**1 Products affected**

Product hierarchy no. *			Part no.	SBU	Type / Description	Customer part no.
SBU   PG	PGU	Type				
02	005	016	0000001169	See list below	Power Entry Modules w/o Filters	DD11

DD11					0118.2182	
creation date	created by	release date	released by	notification no.	revision	page
2013-07-29	hollenpe	2013-12-04	hollenpe	25005	-	1 of 2

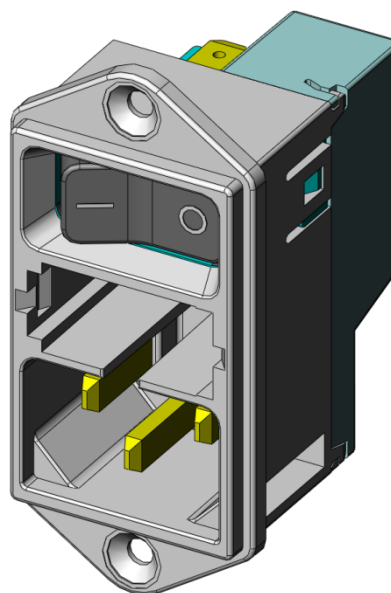
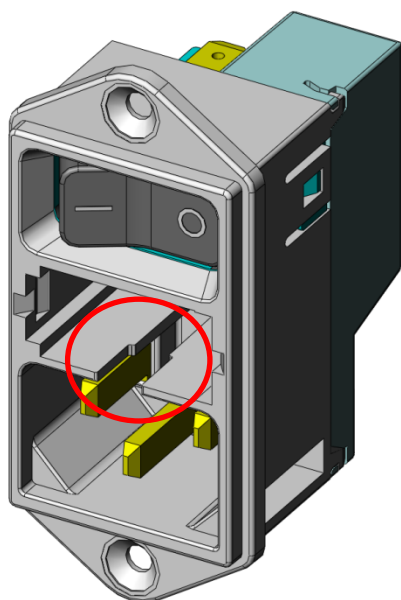
Enlarging of the fusedrawer slot.

Fusedrawer slot enlarged.

New

Old

Implementation of V-Lock cord retention function.  
 Precondition: new fusedrawer required (see PCN 0118.2133).

Form: New form is fully backwards compatible (can be used with old fusedrawer, see PCN 0118.2133).  
 Fit: n/a  
 Function: The new expanded slot allows applying V-Lock cord sets for cord retaining (new fuse drawer necessary).  
 Production Site: n/a  
 Product Label: n/a
